UNITED STATES PATENT AND TRADEMARK OFFICE

APPLICATION NO.	FILING DATE	FIRST NAMED INVENTOR	ATTORNEY DOCKET NO.	CONFIRMATION NO.
10/511,824	10/19/2004	Ian Harley	GB920020037US1	8854

Office Action Summary

DETAILED ACTION

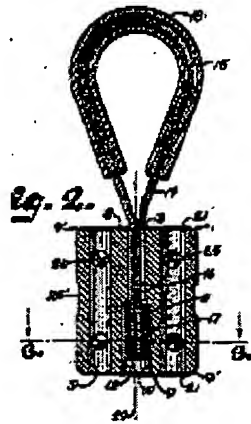
13. Claims 1-6 are rejected under 35 U.S.C. 103(a) as being unpatentable over Bohle et al. (DE 42 03 093) in view of Archer (US Patent No. 4,162,095).

Bohle et al. teaches of a device for gripping and drawing a cable, comprising of an elongated tubular housing for receiving a cable (6) axially and where the cable leaves at an aperture below the device head (5) at one end of the housing and is received back on another side of the same aperture, forming a cable loop at the same end of the housing. Bohle et al. further teaches of a backup lock (9) that has an external thread (10) that can be threaded into an internal winding (2) within the housing in order to further secure. Additionally, Bohle et al. teaches that the cable passes through the housing along a central bore (3), entering at a recess on the side of the housing opposite the aperture opening and exiting at the aperture. Finally, Bohle teaches that the aperture is slanted at 90° with the top of the aperture, thus guiding the cable out through the aperture. However, Bohle et. al. fails to teach of an initial first locking device with a biasing member that temporarily holds the cable loop against the head. (See Fig. 2 and 3 below).

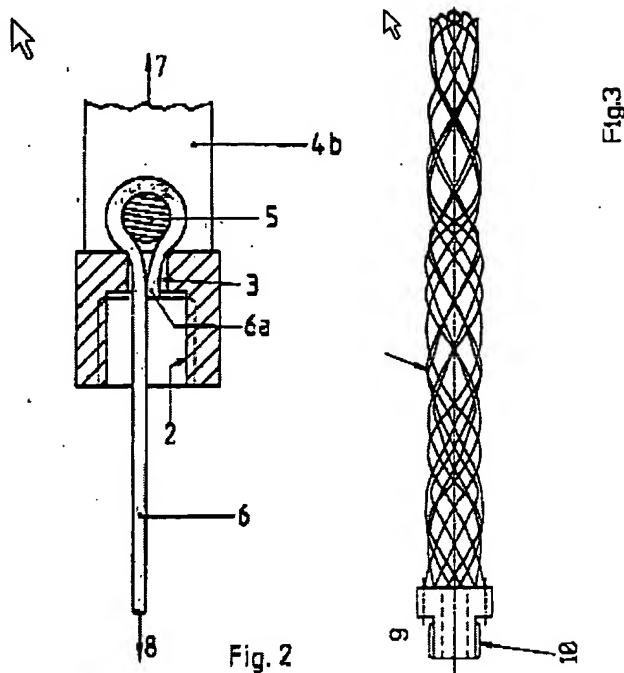
11. Claims 1-4 and 6 are rejected under 35 U.S.C. 102(b) as being clearly anticipated by Ensley (US Patent No. 3,166,810).

Regarding claim 1, Ensley teaches of a cable gripping device that comprises of an elongated housing (7) for receiving a cable axially with the housing being configured to permit an end of the cable to leave and be received back by the housing, forming a loop. Also, the device includes a means for securing part of the cable via a crimping method when the cable is received back by the housing. (See below).

Regarding claim 2, Ensley teaches of a tubular housing (7) wherein the cable passes along a central bore (10) of the housing. Regarding claim 3, Ensley teaches an aperture (11) that opens to one side of the housing with the cable leaving said aperture. Regarding claim 4, Ensley teaches of a recess (13) on a side of the housing opposite the aperture opening, wherein the cable is received in said recess. Regarding claim 6/3 and 6/4, Ensley teaches of a slanted aperture that guides the cable out of the aperture.
